**ADDENDUM | 01**  
**Mary C. Howse Elementary School**  
**641 Boot Road, West Chester, PA 19380**  
**BHA Job No. 22-114**

**DATE OF ISSUANCE:**      **November 17, 2023**

## ADA PARKING DETAIL

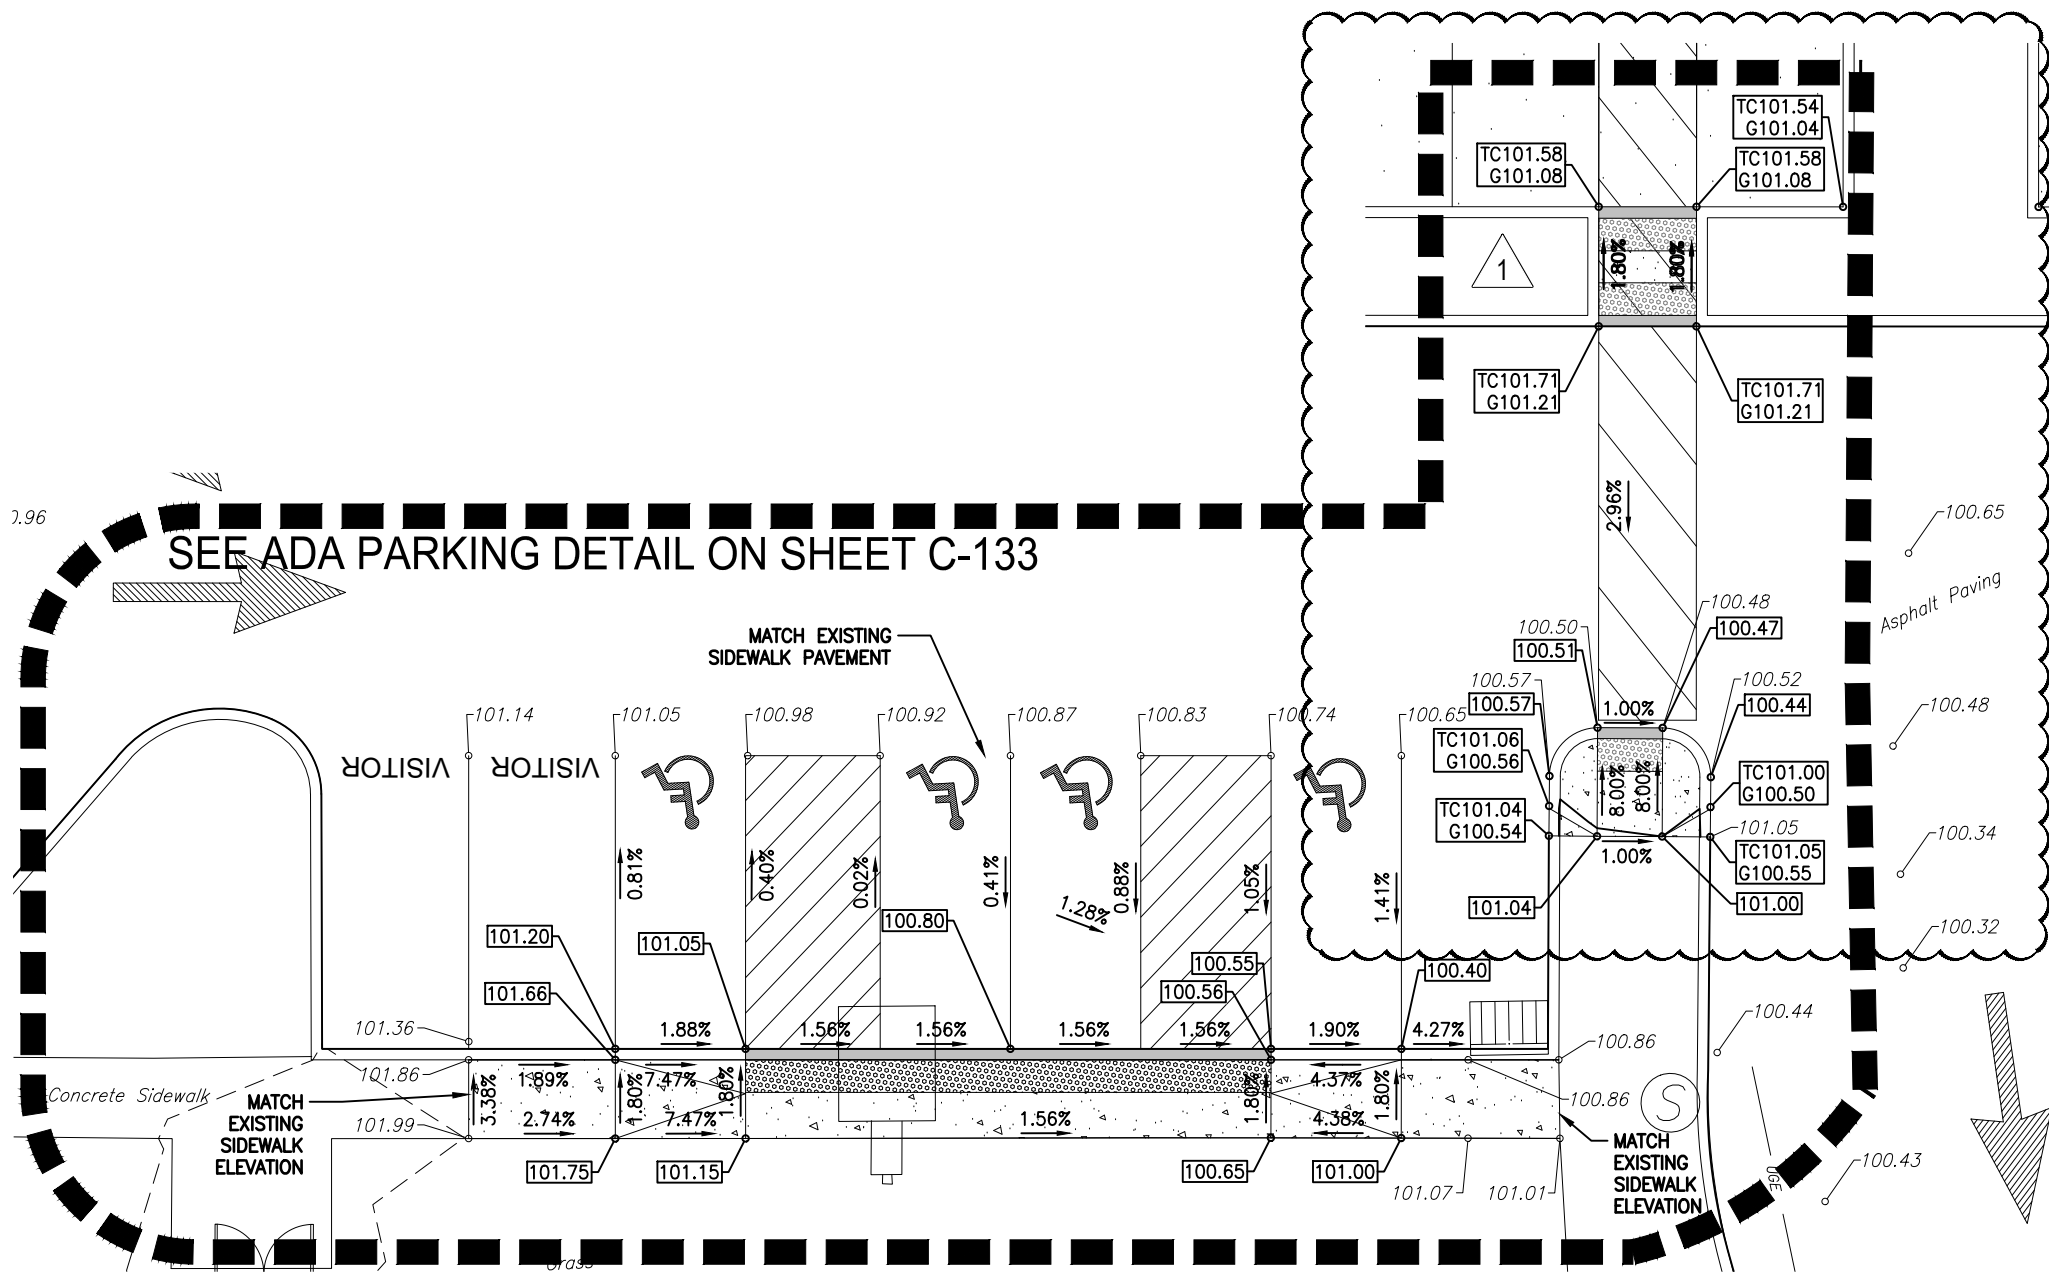
**Stantec Response:** the 5' minimum width of sidewalk has been noted on the sidewalk detail on sheet C-501. The new sidewalk is shown at a minimum of 5' on the plans.

# Compost Sock and Rock Filter Locations

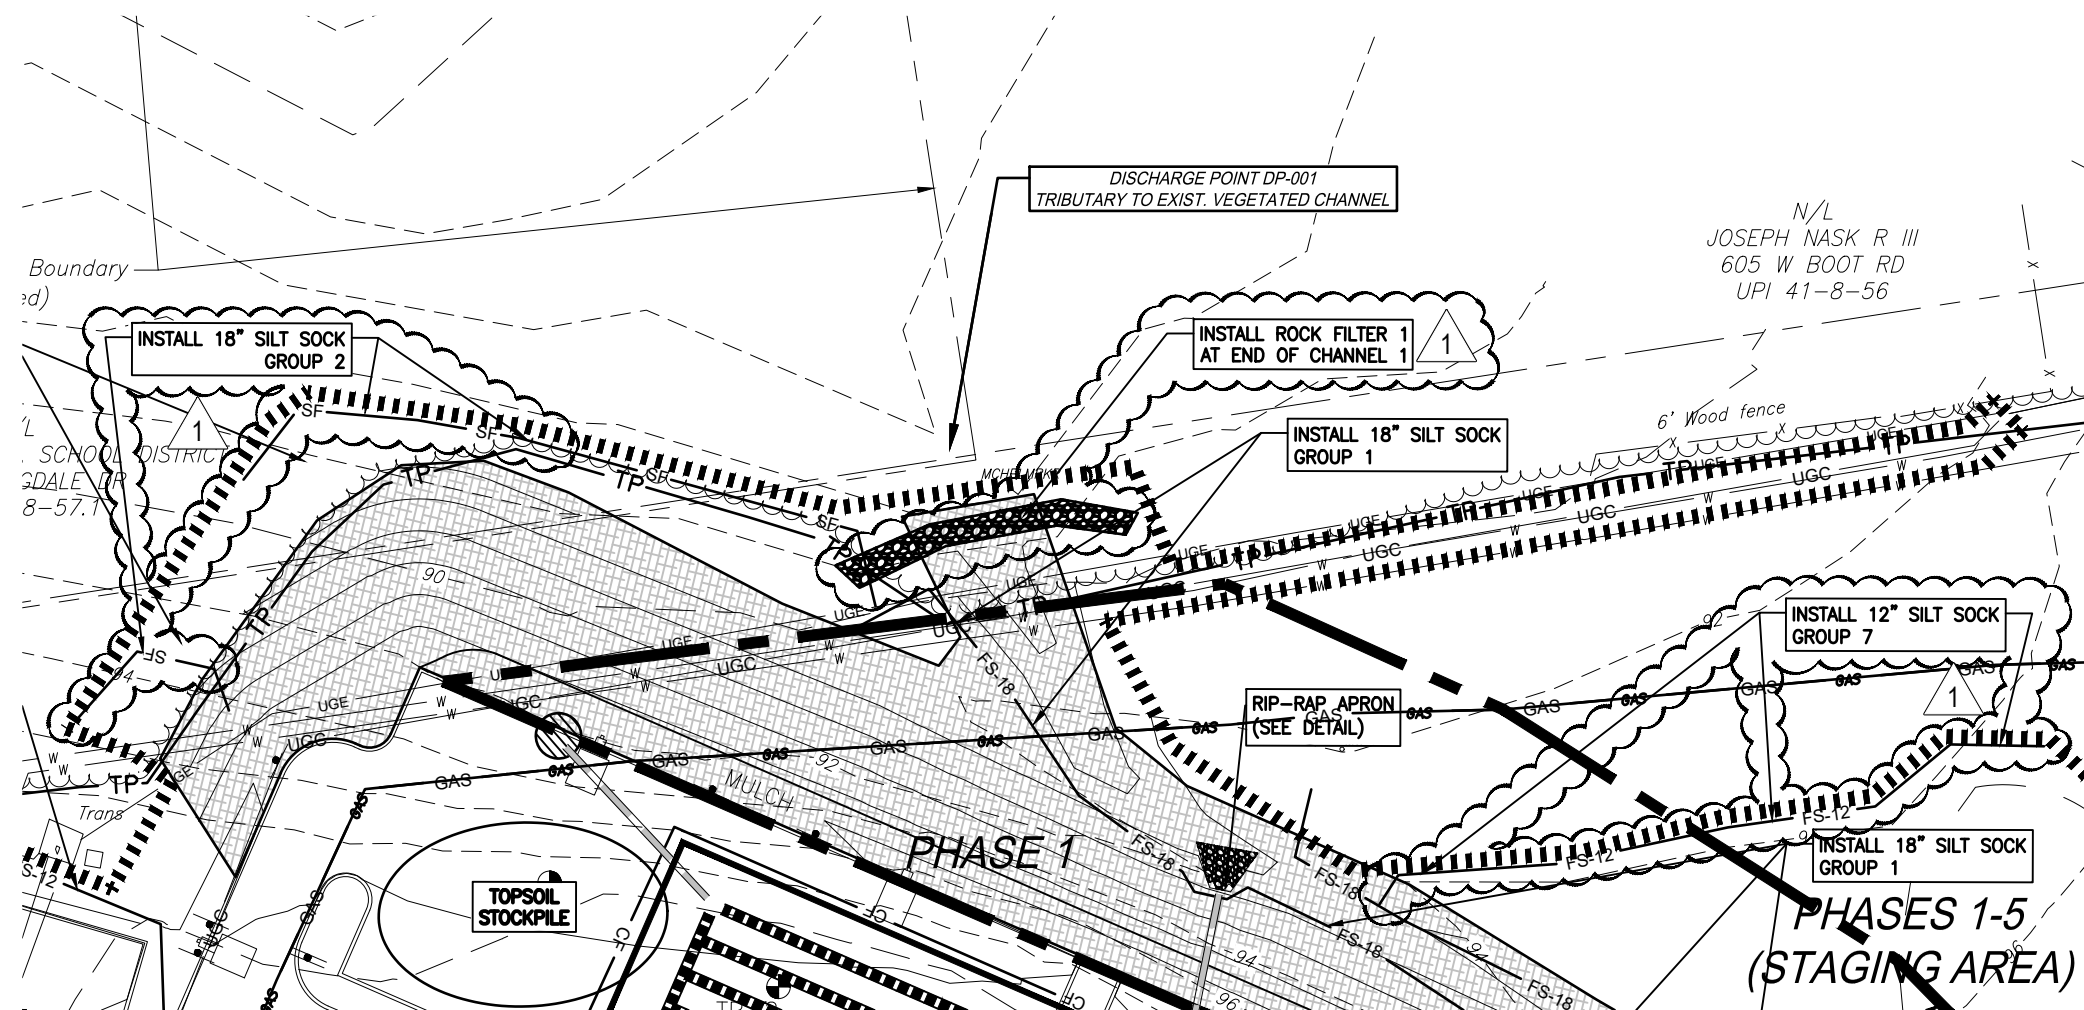
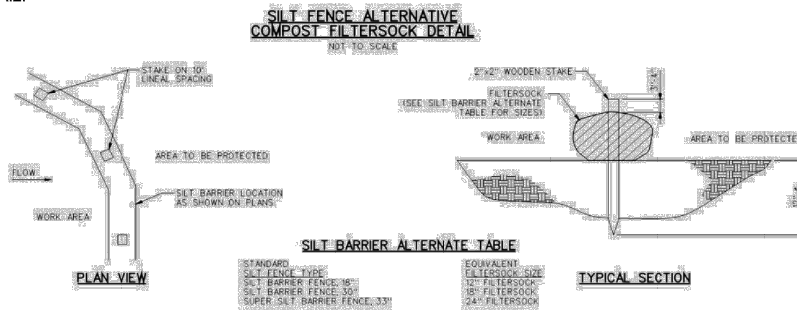
The location of Silt Sock Group 2 has been adjusted but the size and quantity maintained. A new Silt Sock Group 7 has been added to the plan and detail. Group 7 includes 235 feet of 12 inch compost sock.

**Stantec Response: Compost filter sock group 7 has been added along the east side of the staging area on Sheet C-142 and the detail has been updated on Sheet C-144 to include group 7.**

## PLANT MATERIALS LIST – MARY C. HOWSE ELEMENTARY SCHOOL, WEST WHITELAND TWP., PA

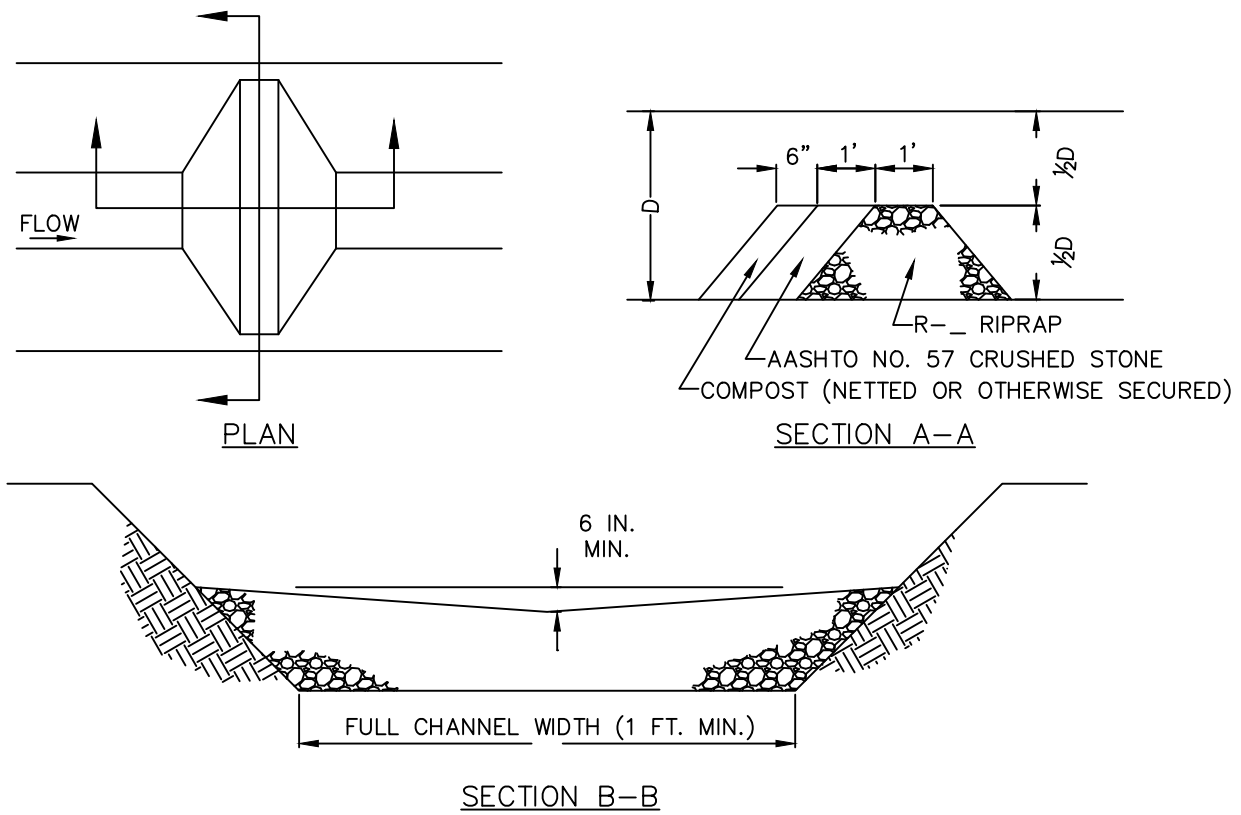
As per discussions with the Township Landscape Consultant, multiple revisions to the locations and number of plantings have been made. For estimating purposes, a revised Plant Material List with the qualities and descriptions of the landscaping from Sheet L-102 is being provided with the addendum.

TREE PROTECTION DETAIL

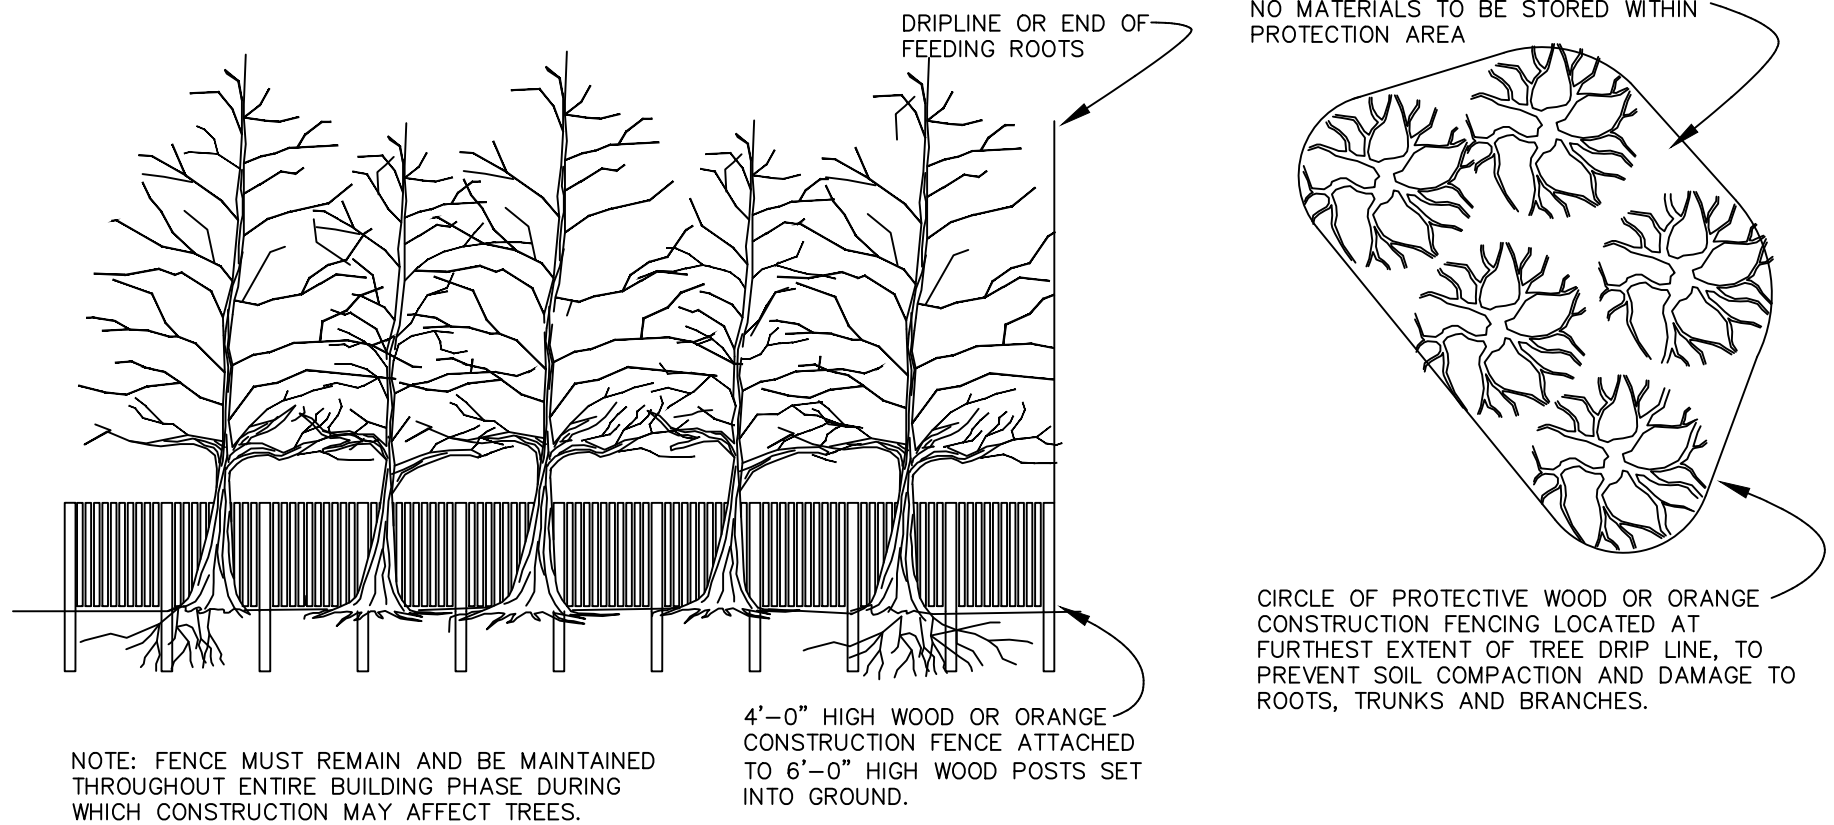
A Tree Protection Detail has been added to the plan sheet.

**Stantec Response:** A tree protection detail has been added to sheet C-144.

1 **ENLARGED DEMOLITION PLAN - GYMNASIUM**  
3/32" = 1'-0"

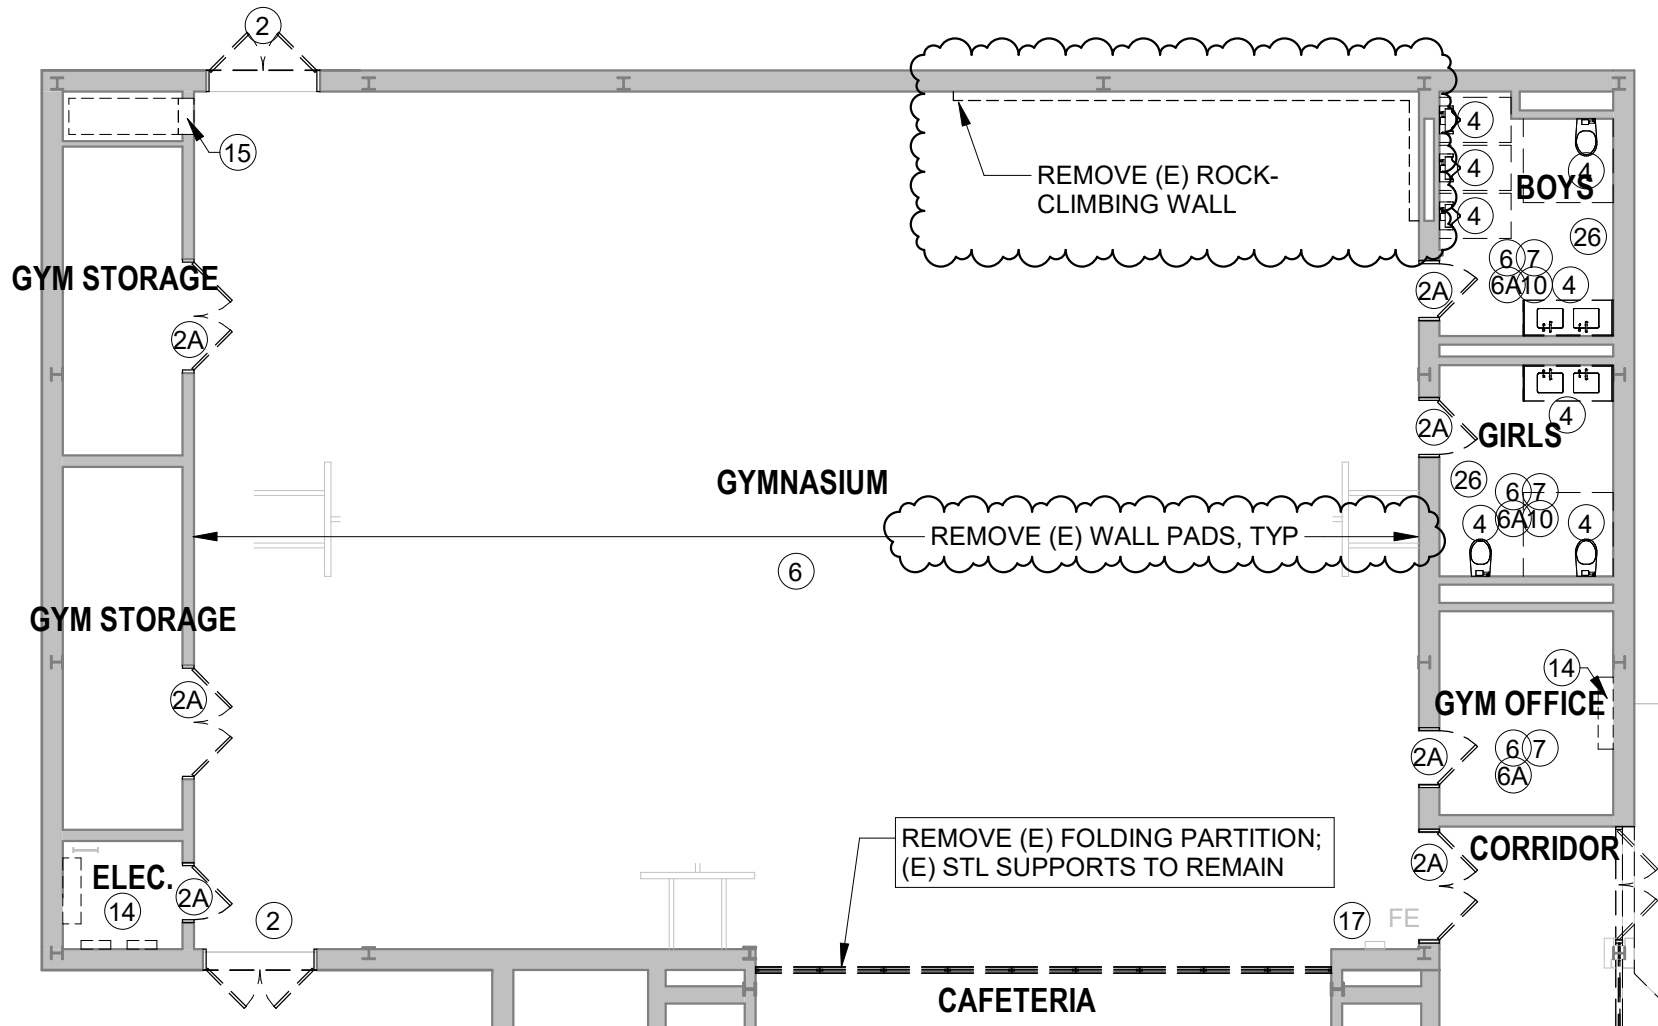
Add note in existing Gymnasium: “REMOVE (E) WALL PADS, TYP”.

Add note in existing Gymnasium: “REMOVE (E) ROCK-CLIMBING WALL”, see SK-1.

**SK-2**

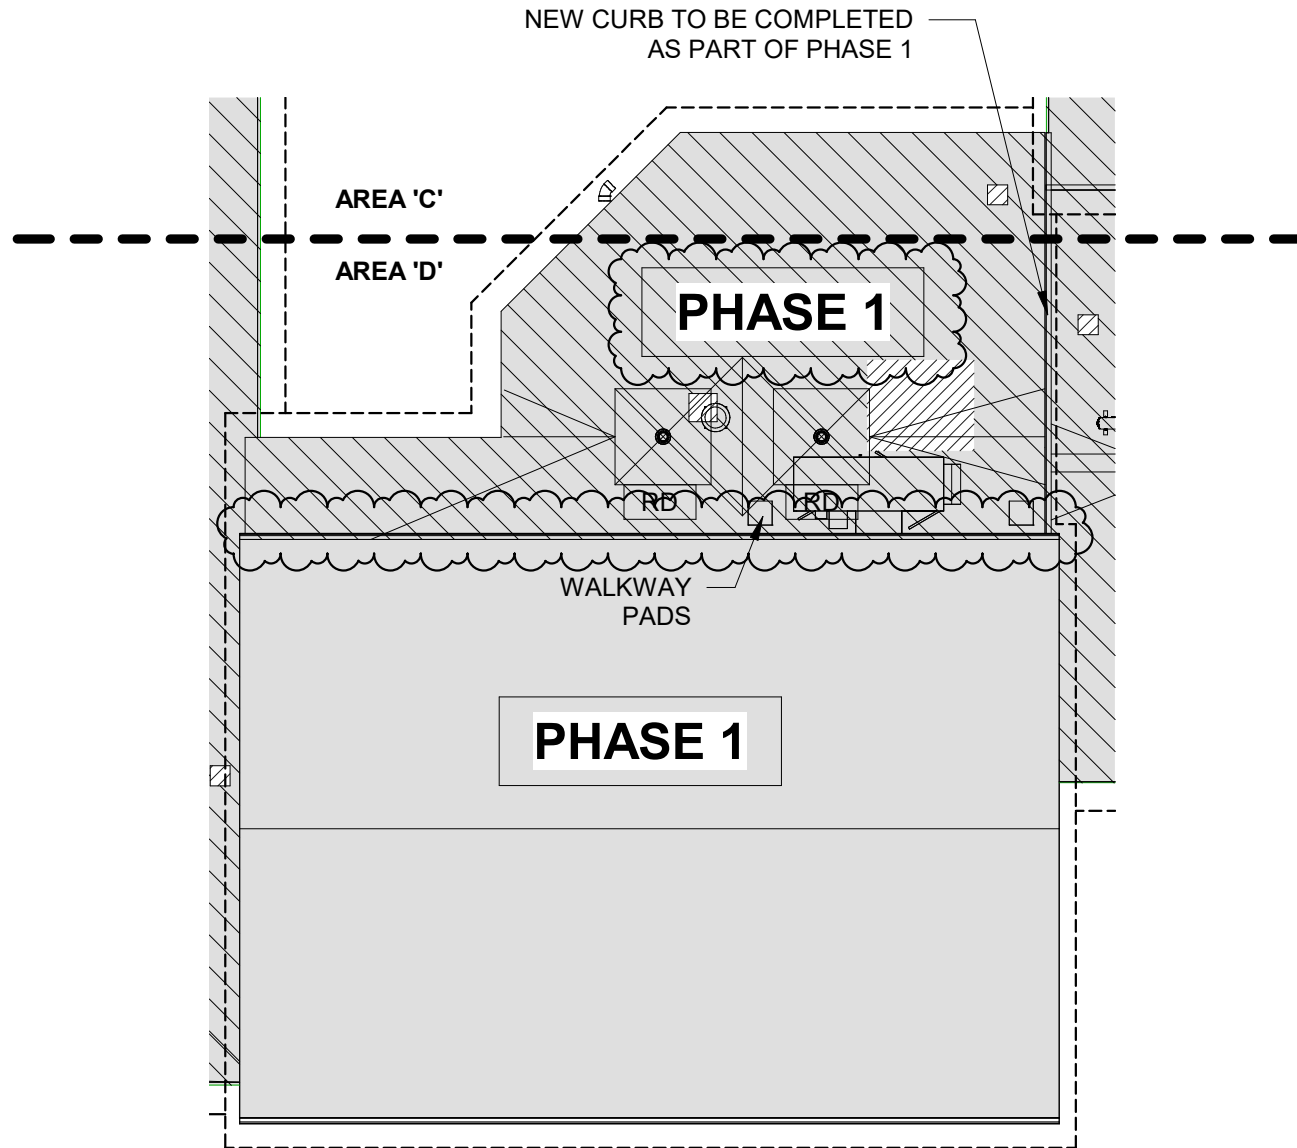
Revise roof area plan-north of the Library (Phase 1) to be part of Phase 1 roof work, not Phase 5. See SK-2.
